ANN ARBOR HISTORIC DISTRICT COMMISSION

Staff Report

ADDRESS: 724 W Jefferson Street, Application Number HDC18-060

APPLICATION: The applicant seeks HDC approval to put a 151 square foot addition on a detached garage located near the rear of the lot, and perform repairs to the historic structure.

1 FIRST FLOOR PLAN-PROPOSED

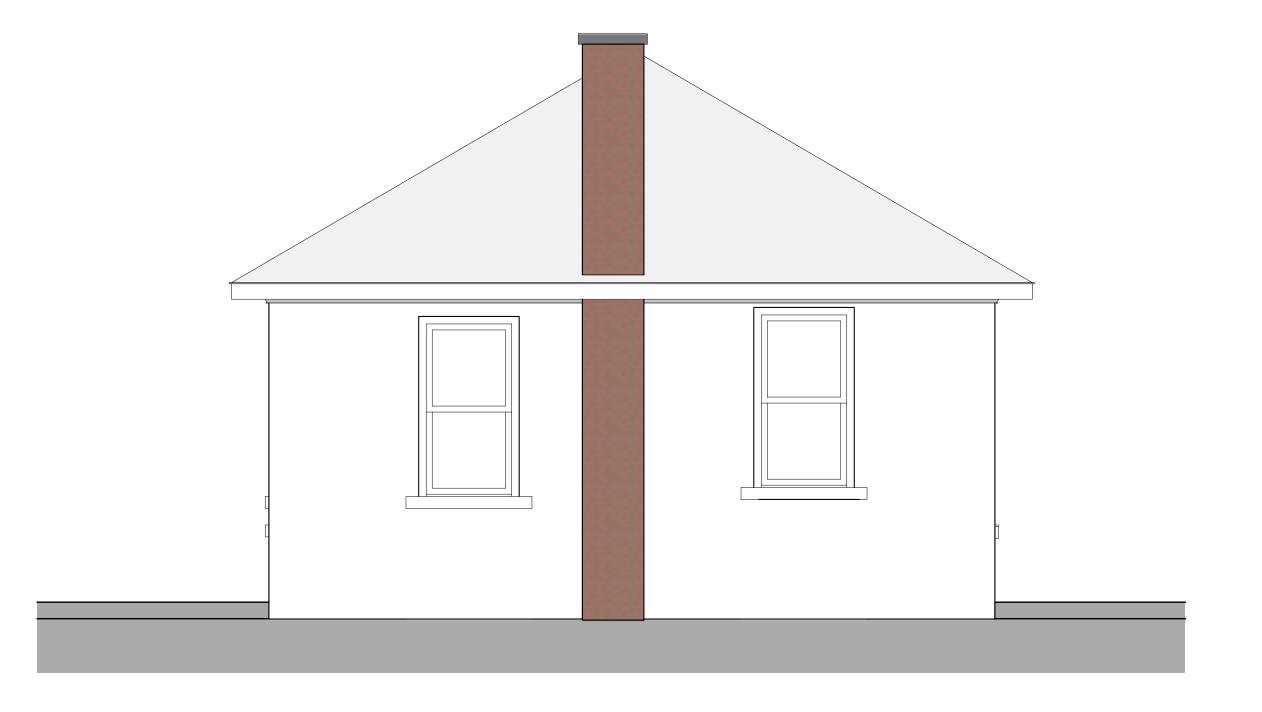
- 2. The proposed addition is 151 square feet on the back of the building. The addition would house a bathroom and storage room. It is 18'10" wide by 8' deep, with 8" corner insets. The red brick chimney would remain, and a metal extension would be added to the top of the chimney to meet code requirements. The addition has a clad wood window in the bathroom, and a steel person door into the storage room. The storage room is not accessible from the interior. The addition ties into the pyramidal roof with a ridge lower than the existing peak. Two skylights are proposed on the east side of the original roof. Cladding is 5" exposure cement board, with corner boards.

- 3. The room will have a wood stove but no central heating. It may not be used as a sleeping room per code, but may be used as a rec room as proposed.

4 NORTH ELEVATION

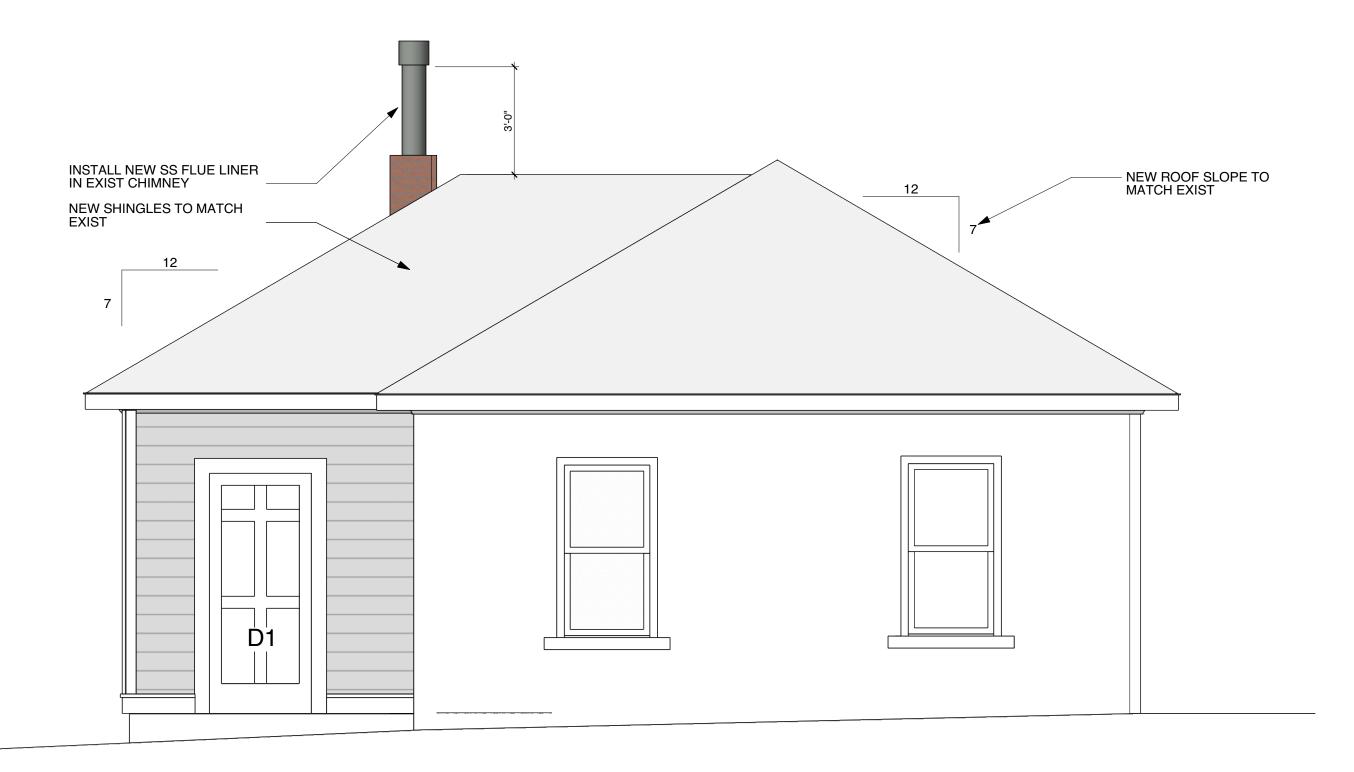
- 4. The design of the addition is compatible with the garage and neighborhood. The addition will be minimally visible from the street and is sensitive to the character of the historic garage. Staff believes the work generally meets the Ann Arbor Historic District Design Guidelines and the Secretary of the Interior's Guidelines and Standards for Rehabilitation.
